PROJECT NUMBER: SP2022-007
PROJECT NAME: Site Plan for Gideon Grove Phase 2
SITE ADDRESS/LOCATIONS:

DEPARTMENT	REVIEWER	DATE OF REVIEW	STATUS OF PROJECT
PLANNING	Henry Lee	02/25/2022	Approved w/ Comments

SUBJECT: SP2022-007; *Site Plan for Gideon Grove Phase 2 Subdivision*

A MONUMENT SIGN DETAIL
NOT TO SCALE

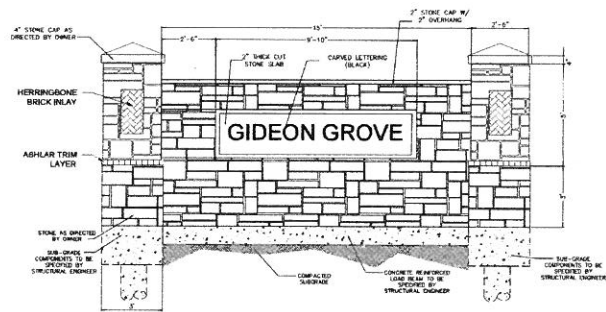
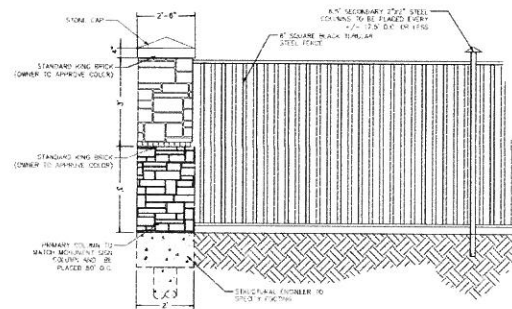
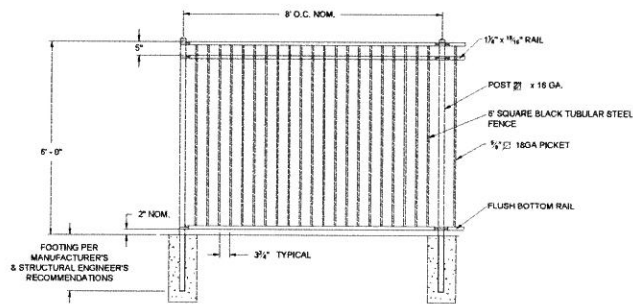
- No signage/structures in easements. Show sewer and drainage easements near sign.

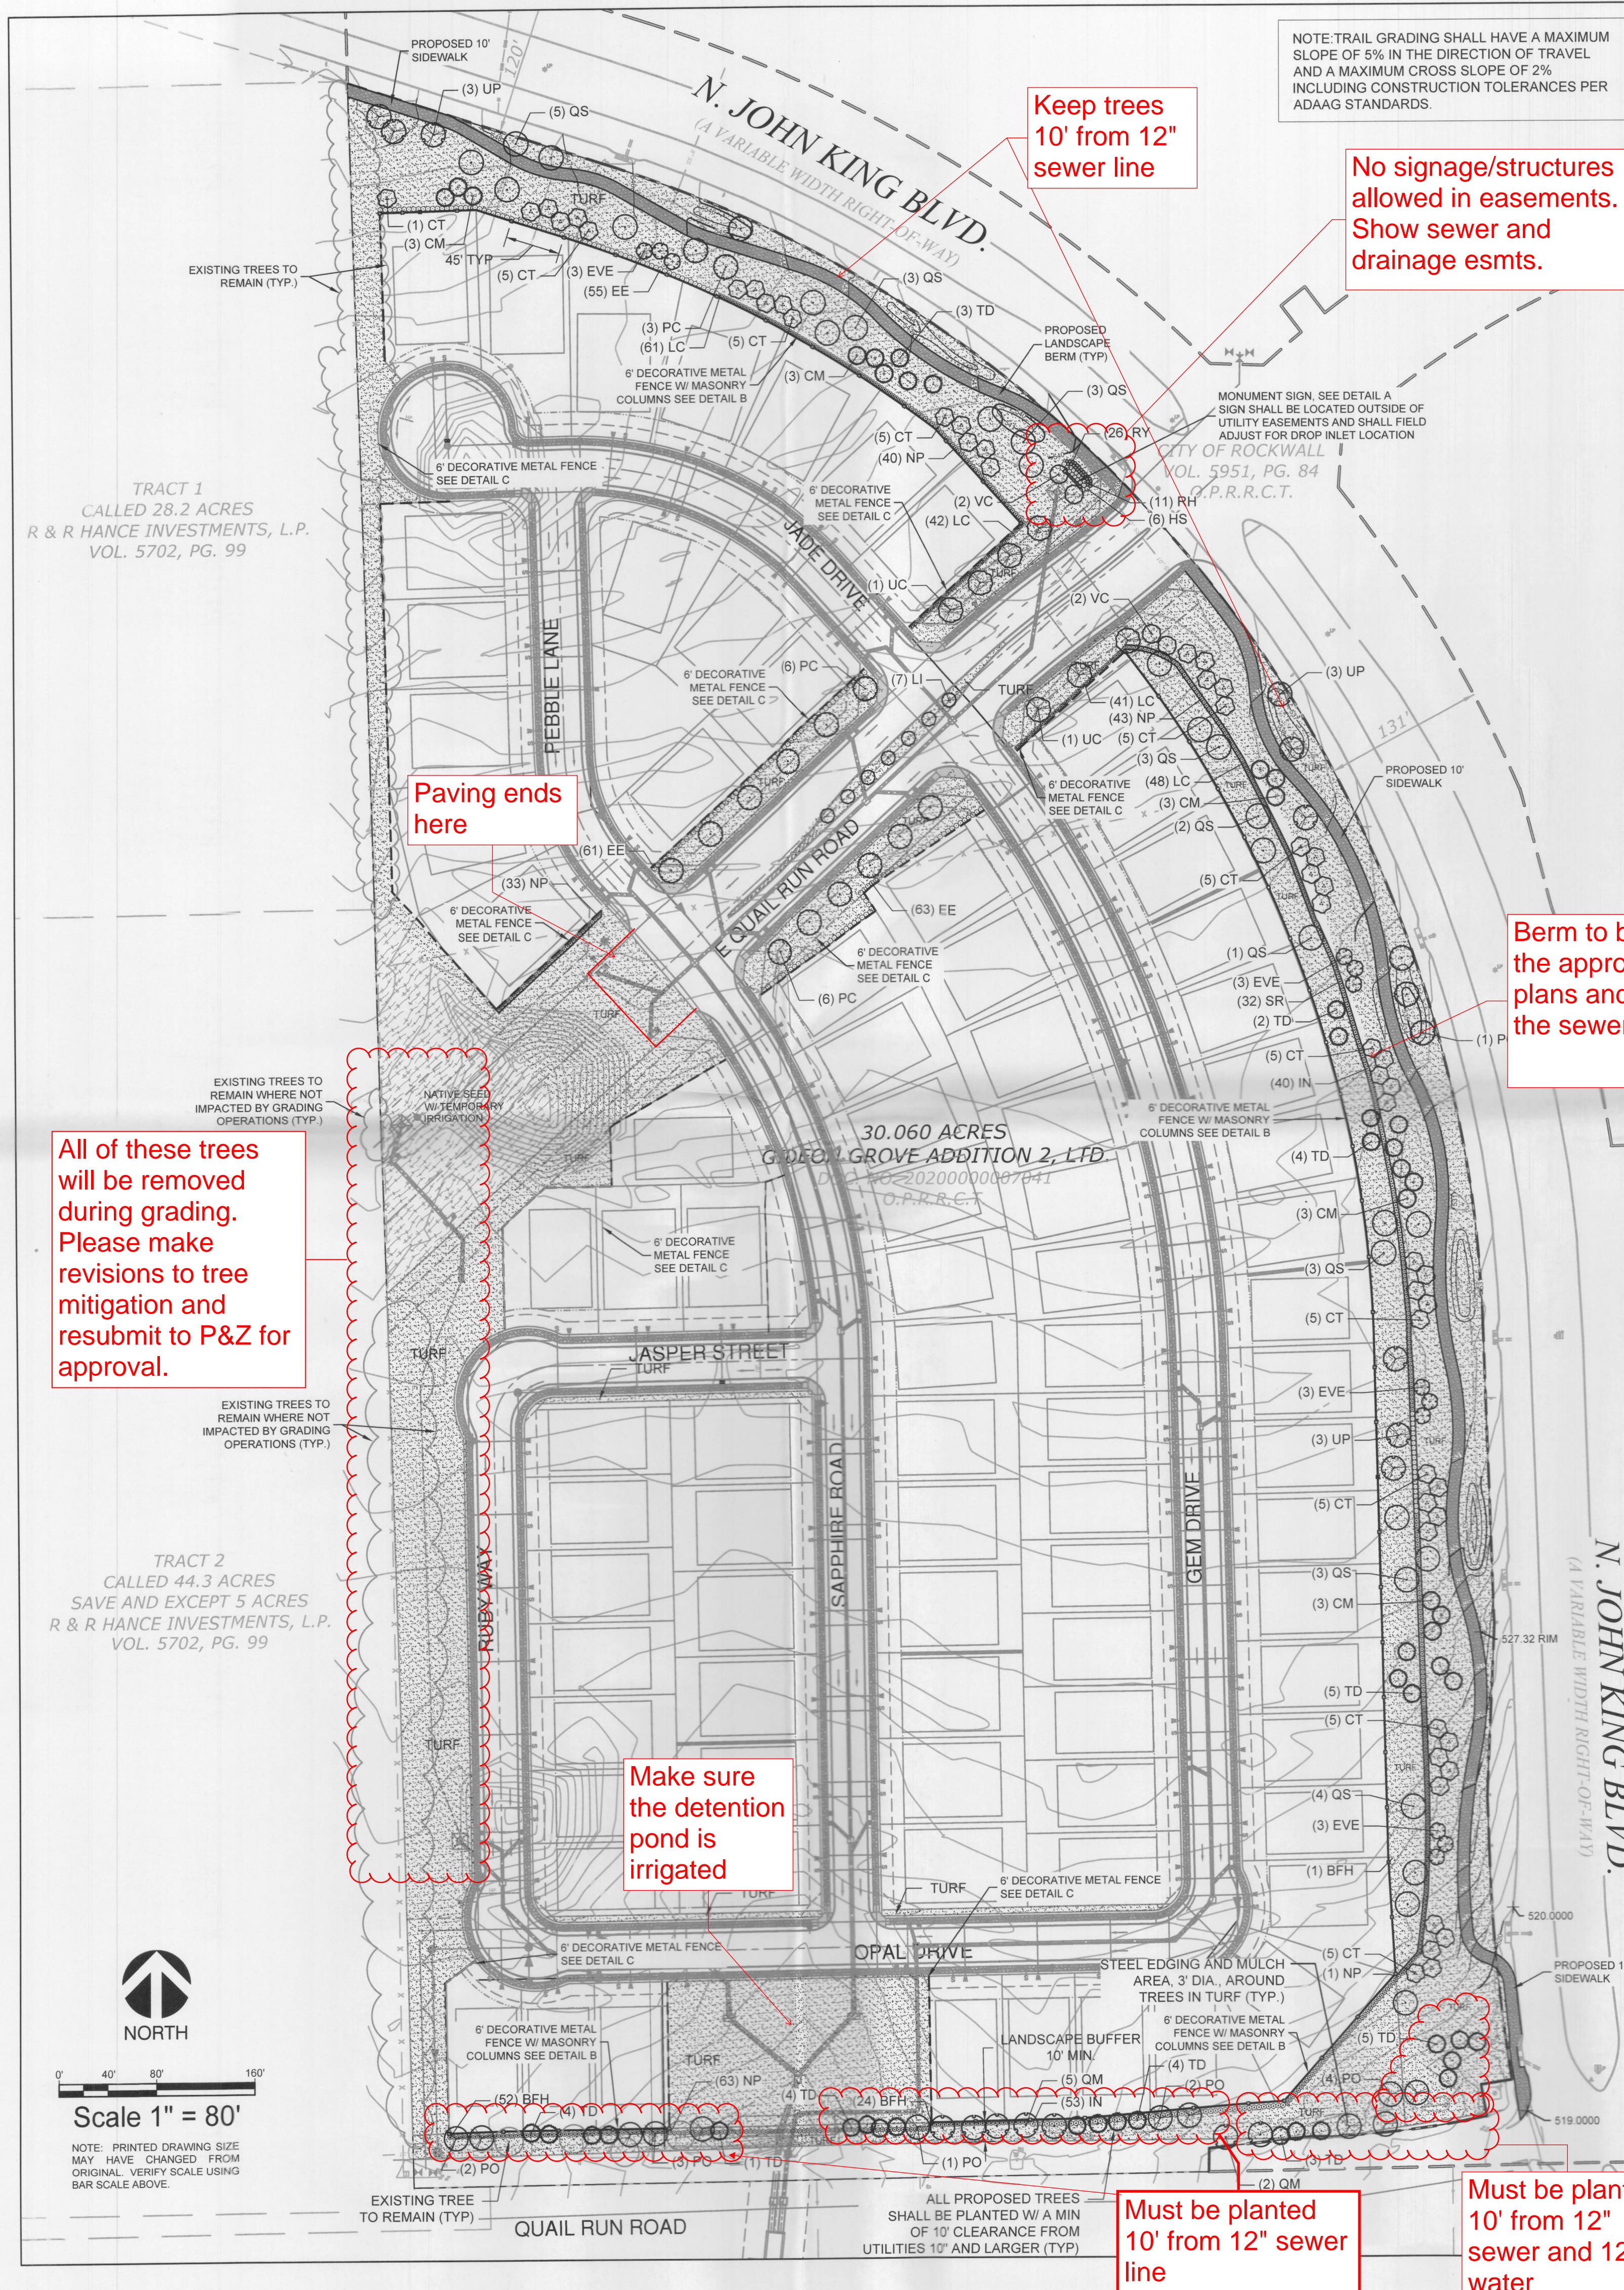
02/22/2022: If the area on the south end is a detention pond, the area must have 1 canopy tree and 1 accent trees planted around the perimeter for every 750 sqft of detention.
